APPLICATION NO.	FILING DATE	FIRST NAMED INVENTOR	ATTORNEY DOCKET NO.	CONFIRMATION NO.
10/594,904	04/25/2007	Kazuto Sakemura	46969-5456	8306
	7590 08/13/200 DDLE & REATH (DC)	EXAMINER		
1500 K STREET, N.W.			BOWMAN, MARY ELLEN	
SUITE 1100 WASHINGTON, DC 20005-1209			ART UNIT	PAPER NUMBER
			4174	
			MAIL DATE	DELIVERY MODE
			08/13/2008	PAPER

Application No.	Applicant(s)				
Office Action Comments	10/594,904	SAKEMURA ET AL.				
Office Action Summary	Examiner	Art Unit				
	MARY ELLEN BOWMAN	4174				
The MAILING DATE of this communication app Period for Reply	pears on the cover sheet with the c	orrespondence address				
A SHORTENED STATUTORY PERIOD FOR REPLY IS SET TO EXPIRE 3 MONTH(S) OR THIRTY (30) DAYS, WHICHEVER IS LONGER, FROM THE MAILING DATE OF THIS COMMUNICATION.  - Extensions of time may be available under the provisions of 37 CFR 1.136(a). In no event, however, may a reply be timely filed after SIX (6) MONTHS from the mailing date of this communication.  - If NO period for reply is specified above, the maximum statutory period will apply and will expire SIX (6) MONTHS from the mailing date of this communication.  - Failure to reply within the set or extended period for repl

Fig. 2

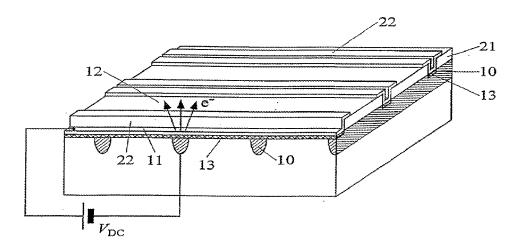
electrode]...where electrons 12 are emitted...electrons that travel ballistically through and are emitted at 12 from the second conductors 11 [i.e., through the upper electrode]"), characterized in that the electron emitting elements are made independent and in that space is formed therebetween (e.g., Figure 2 below; electron emitting elements 12 are independent and spaced apart), and in that the upper electrode extends across the plurality of electron emitting elements and the space by a bridging portion of the upper electrode (e.g., Figure 2 below; upper electrode 11 extends across the space between the electron emitting elements 12).

- 6. Regarding claim 2, Brune teaches the invention as explained above regarding claim 1 and further teaches the bridge portion is provided with at least one through hole or notched portion (e.g., Figure 2 above, upper electrode 11 is provided with a notched portion corresponding to the bridge portion of the electrode that extends over electron emitting elements 12 as explained above regarding claim 1).
- 7. Regarding claim 3, Brune teaches the invention as explained above regarding claim 2 and further teaches the through hole or notched portion is circular-shaped, rectangular-shaped,

diamond-shaped, barrel-shaped, star-shaped, shoulder drum shaped, or a shape formed of part of these shapes (e.g., Figure 2 above, the notched portion of upper electrode 11 is rectangular shaped).

- 8. Regarding claim 4, Brune teaches the invention as explained above regarding claim 1 and further teaches the bridge portion extends approximately parallel to the substrate (e.g., Figure 2 above, the bridge portion of the upper electrode 11 which extends over electron emitting elements 12 is approximately parallel to the substrate).

- 9. Regarding claim 5, Brune teaches the invention as explained above regarding claim 1 and further teaches both the lower electrode, and the upper electrode connected at the bridge portions or strip shaped electrodes arranged in positions that are mutually orthogonal (e.g., Figure 2 above, stripe shaped lower electrode 10 and stripe shaped upper electrode 11 intersect at the bridge portions and are mutually orthogonal).

Fig. 2

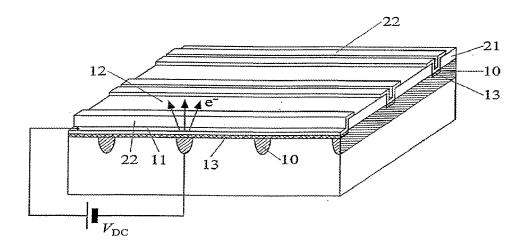
film thickness of the insulator layer and the upper electrode gradually decreases towards the electron supply layer (e.g., Figure 2 below, the thickness of the insulator layer 21 and upper electrode layer 11 steps down, or gradually decreases, to form island areas over each electron emitting element).

- 15. Regarding claim 11, Brune teaches the invention as explained above regarding claim 10 and further teaches in the island areas the upper electrode terminates on the insulator layer (e.g., Figure 2 above, upper electrode 11 terminates as metal layer 22 on insulator layer 21).
- 16. Regarding claim 12, Brune teaches the inventions as explained above regarding claim 10 or 11 and further teaches in the island areas the insulator layer terminates on the electron supply layer (e.g., Figure 2 above, insulator layer 21 terminates on electron supply layer 13 at the island areas).
- 17. Regarding claim 13, Brune teaches the invention as explained above regarding claim 10 and further teaches the island areas are depressions in the flat surface of the upper electrode (e.g., Figure 2 above, island areas are depressions in the flat surface of upper electrode 11).

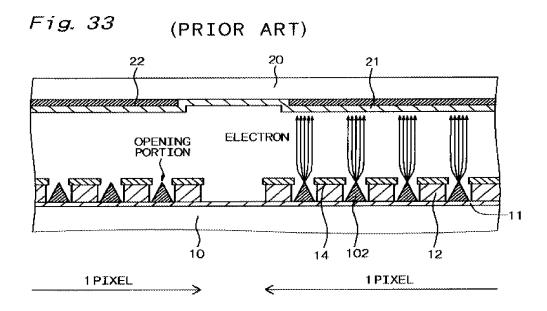
- 28. Regarding claim 24, Kikuchi teaches an imaging element (e.g., col 1, lines 17-18; "various flat panel type displays for an image displaying unit") comprising: the invention as explained above regarding claim 1 (as taught by Brune); a photoelectric conversion film approximately parallel to and opposed to the upper electrode and enclosing a vacuum space; an optically transparent electrically conducting film deposited on the photoelectric conversion film; and an optically transparent front substrate that supports the photoelectric conversion film and the optically transparent electrically conducting film (e.g., col 1, lines 52-55; "a second electrode layer (anode electrode layer) 21 [i.e., optically transparent electrically conducting film] formed on a transparent substrate 20 [i.e., optically transparent front substrate] to collide with a fluorescent layer (light emitting layer) 22 [i.e., a photoelectric conversion film] formed between the anode electrode layer 21 and the transparent substrate 20"; see Figure 33 below).

- 29. Regarding claim 25, Kikuchi teaches the invention as explained above regarding claim 25 and further teaches a mesh electrode arranged within the vacuum so as to not contact the electron emitting device of the photoelectric conversion film (e.g., Figure 33 above, gate electrode 14 is a mesh electrode within the vacuum that does not contact the electron emitting element 12).

- 30. Regarding claim 26, Kikuchi teaches a display device comprising: the invention as explained above regarding claim 1; and an optically transparent front substrate in opposition to the upper electrode (e.g., Figure 33 above, transparent substrate 20) and enclosing a vacuum space, with a fluorescent layer arranged on the surface on the side of the vacuum space (e.g., Figure 33 above, fluorescent layer 22), and a collector electrode formed on the fluorescent layer and in opposition to the upper electrode (e.g., Figure 33 above, collector electrode 21 is formed on fluorescent layer 22 and opposite upper electrode 14).

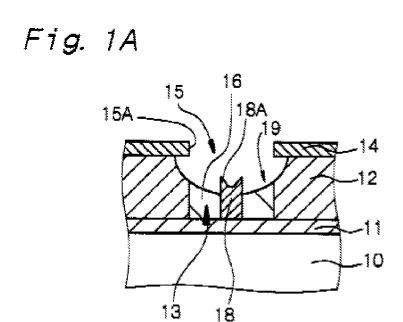
- 43. Regarding claim 22, Kikuchi and Sato teach the inventions as explained above regarding claim 20 or 21, and Kikuchi further teaches in the bridge forming step the upper electrode and the insulator layer are etched by the isotropic etching method to form bridge portions including the material part of the insulator layer integral with the insulator layers and upper electrodes of adjacent electron emitting elements, in the through holes or notches bridge portions are formed including the material part of the insulator layer, and a canopy-shaped structure made from the material of the insulator layer is formed in the through holes or notches projecting towards the center of the through holes or the inside of the notches (e.g., col 25, lines 58-62; "after the etching of the gate electrode 14 [i.e., upper electrode], while the resist layer 40 is used as an etching mask, the opening portion 13 is formed in the insulating interlayer 12 below the opening portion 15 formed in the gate electrode 14 so as to reach the electrode layer 11 [i.e., lower electrode] by an RIE method suing carbon tetrafluoride (CF<sub>4</sub>) gas"; see also Figure 1A below,

insulator layer 12 projects in toward the center of the through hole 15 and a canopy shaped structure is produced).
